Ex. 4  
From: <Dodd@~~\_\_\_\_\_~~>  
To: <WLS@nrc.gov> W Schmidt  
Date: Tue, Jul 18, 2000 4:21 PM  
Subject: Missed tubes

## Review of 1997 inspection of U-bend tubes at Indian Point2

**Figure 1** 400 kHz C-scan of tube 2-69 of steam generator 24 made in 1997

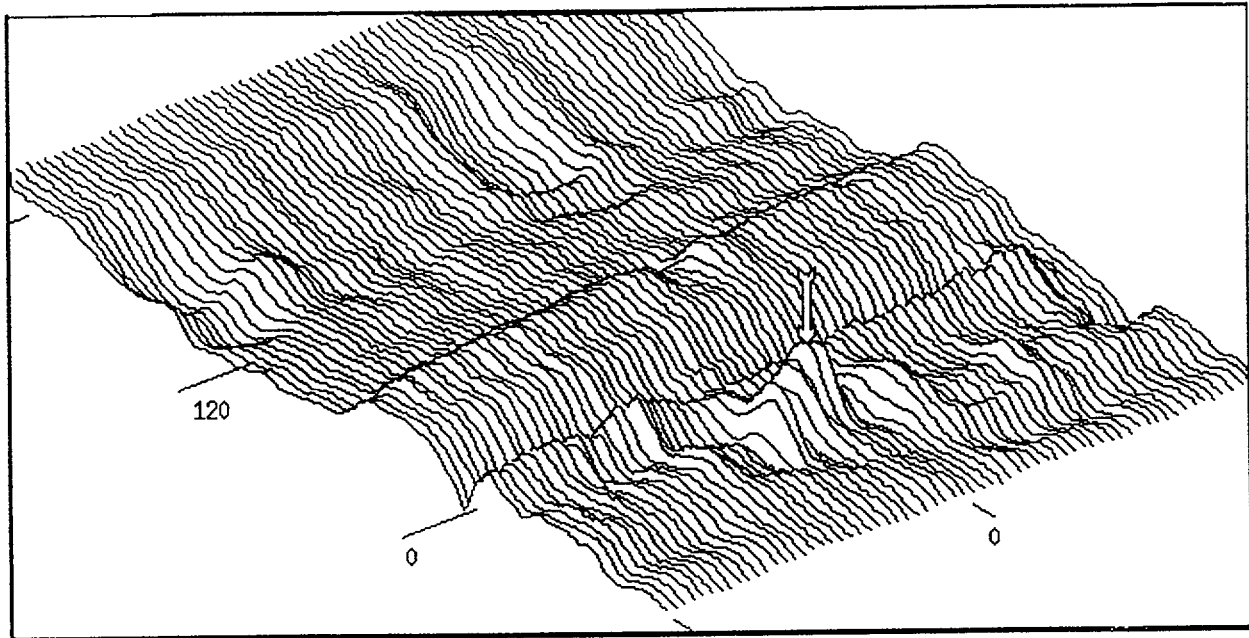
The 400 kHz C-scan of tube 2-69 of steam generator 24, made in 1997, is shown in Figure 1. While the amplitude of this signal is small (1.2-volts), it does stand up above the noise, enough at

least for the analyst to look at the Lissajous of the signal.

**Figure 2** 400 kHz C-scan of tube 2-87 of steam generator 21 made in 1997

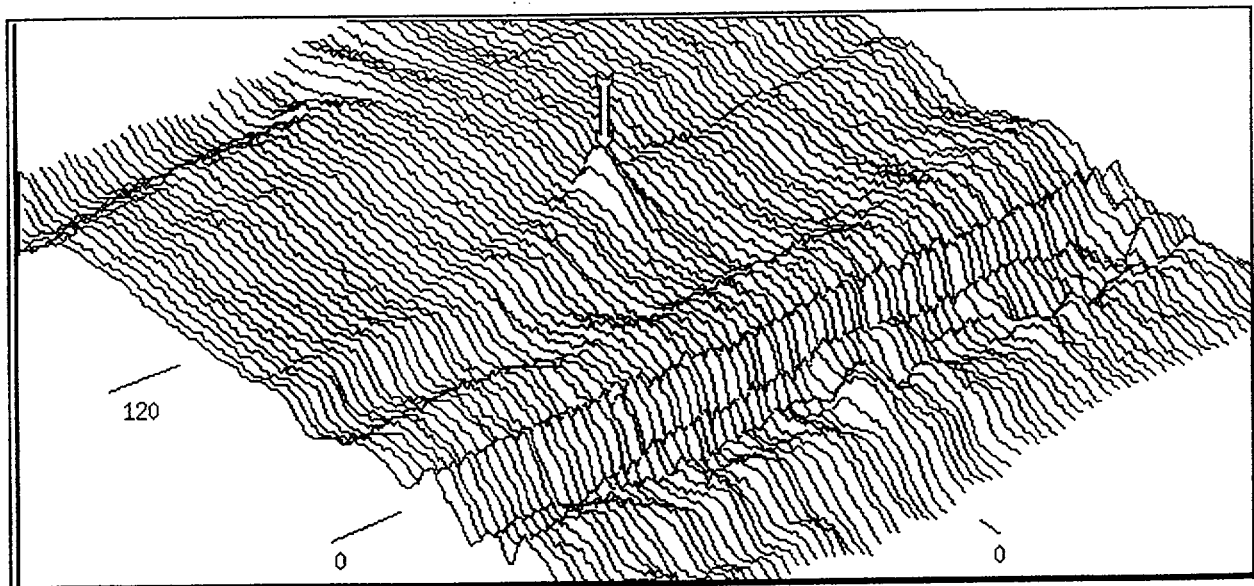
The C-scan of tube 2-87 of steam generator 21 is shown in Figure 2. This tube has a defect signals of about 1-volt in a relatively clear part of the tube. This signal looks very much like the one found in tube 2-67 during the 1997 outage. A careful examination of the C-scan of this tube will show enough of a signal for the analyst to look at the Lissajous signal. This tube also has several long cracks at about the same axial location as the defect that is in the clean section. They are partially obscured by a noise ridge.

**Figure 3** 400 kHz C-scan of tube 2-5 of steam generator 24 made in 1997

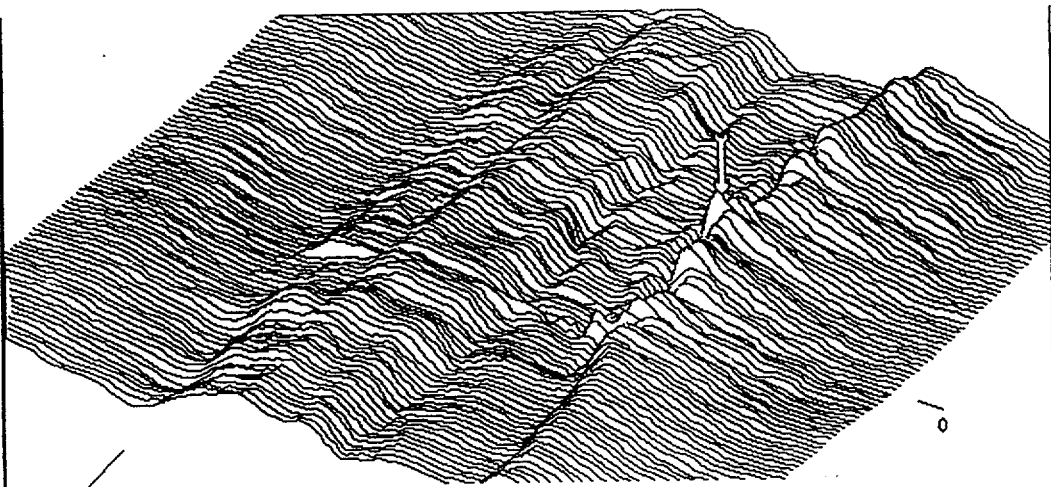
The C-scan of tube 2-5 of steam generator 24, made at 400 kHz in 1997 is shown in Figure 3. The defect is shown riding on top of the deposit ridge. This defect becomes much more apparent if a circumferential average filter is used. The use of this filter on tube 2-5 is shown in Figure 4. This type of filter computes the average value of the vertical

**Figure 4** 400 kHz C-scan of tube 2-5 of steam generator 24 using a circumferential average filter.

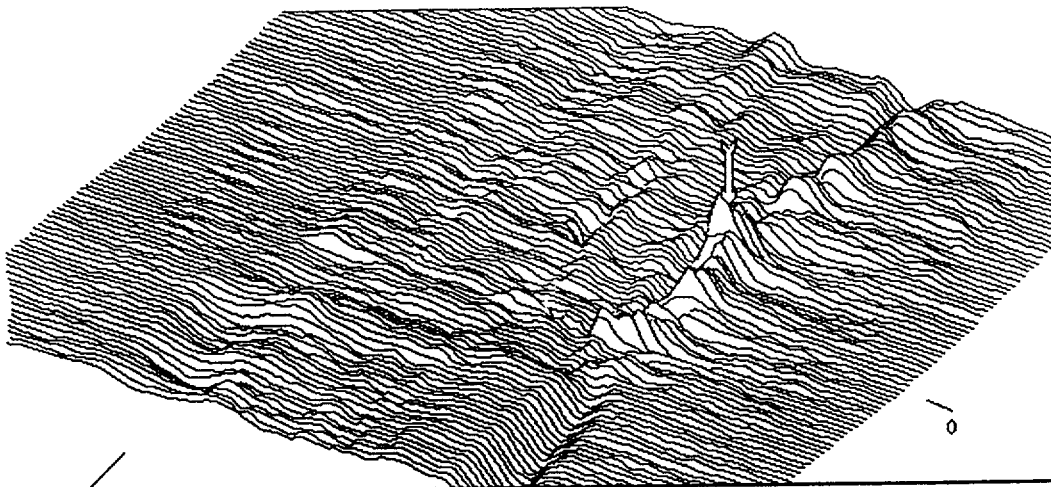
component of the signal over all of the axial extent of the scan, for each point around the circumference of the tube. This average value is then subtracted from the scan, and the scan of the difference is re-plotted. This is particularly effective in removing the long ridges of noise from the scans. The differences in the axial direction are then emphasized. The 1997 guidelines state that "Mixing and filters are not required but are optional." In general, Westinghouse does not encourage the use of filters.

**Figure 5** 400 kHz C-scan of tube 2-72 of steam generator 24 made in 1997, with no filter applied

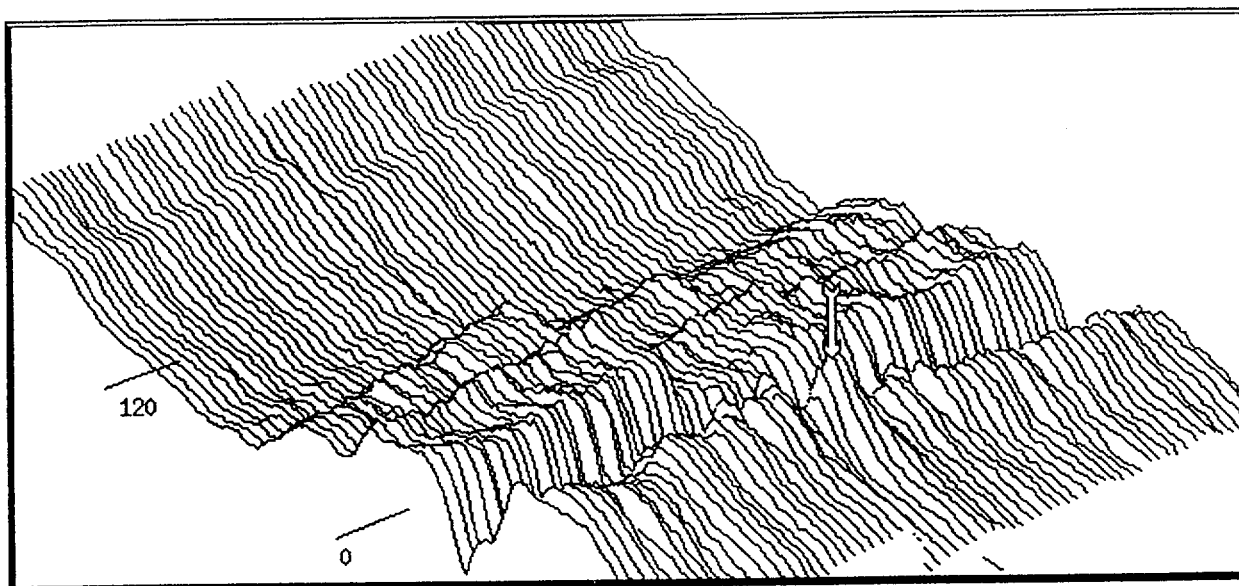
Tube 2-72 of Steam generator 24 is similar to tube 2-5, and could possibly be detected from the C-scan, without the need of any filter, although a circumferential average filter would have

helped here also. This tube is shown in Figure 5.

Figure 7 Tube 2-85 of SG23 in 1997 at 400 kHz, with circumferential average filter applied.

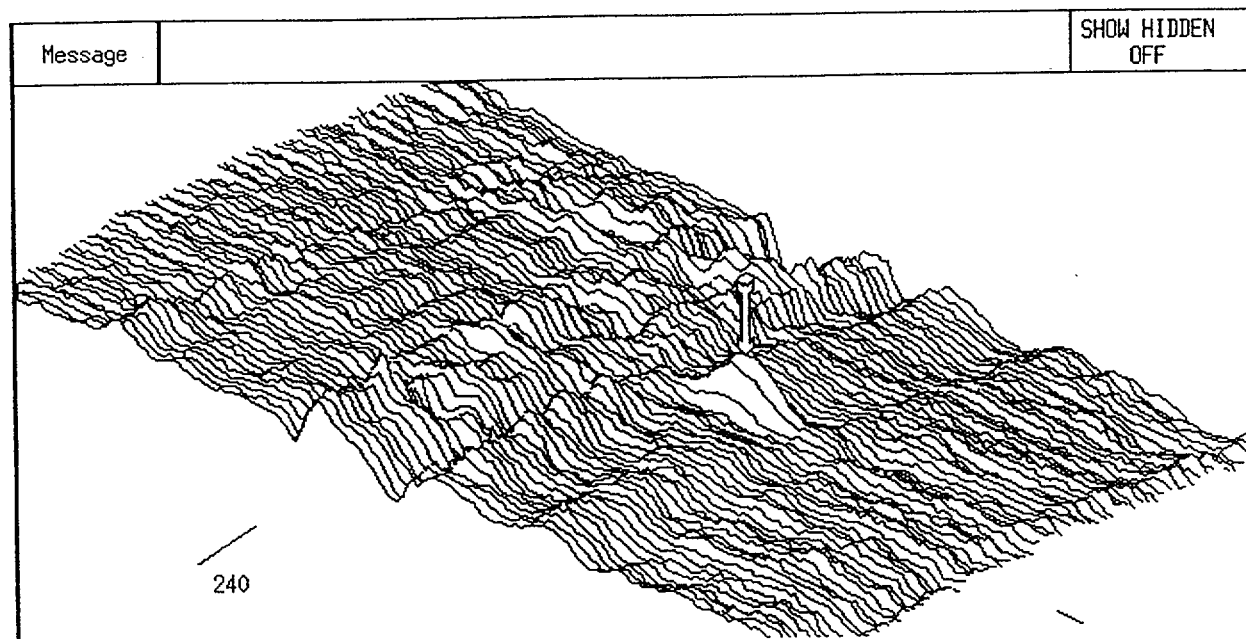
Tube 2-85 of steam generator 23 also needs the circumferential filter for detection, as shown in Figure 7.

Figure 6 Tube 2-71 of SG24 in 1997 at 400 kHz, with circumferential average filter applied.

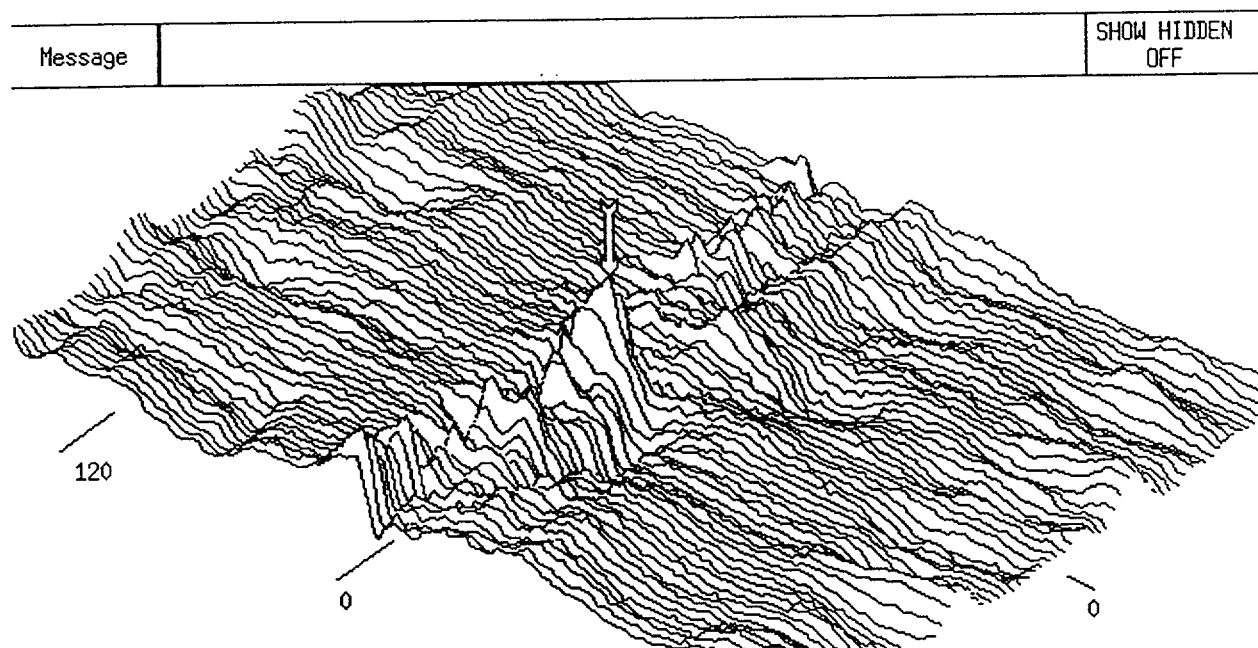
Tube 2-71, as shown in Figure 6 needs the circumferential average filter applied for detection.
